STOCK NO. 164043
DESCRIPTION: COIL

Horizontal Oscillator Kit — CTC131/132

FIG. 1

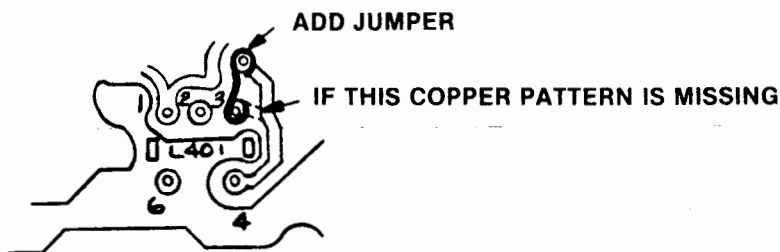
- If L401 in chassis being serviced is labeled 333-7, use all parts in the kit to replace original parts.
 - If L401 in chassis being serviced is labeled 333-8, individual components may be replaced.
- Check the chassis printed circuit in the area shown in Figure 1 and add the jumper if required.
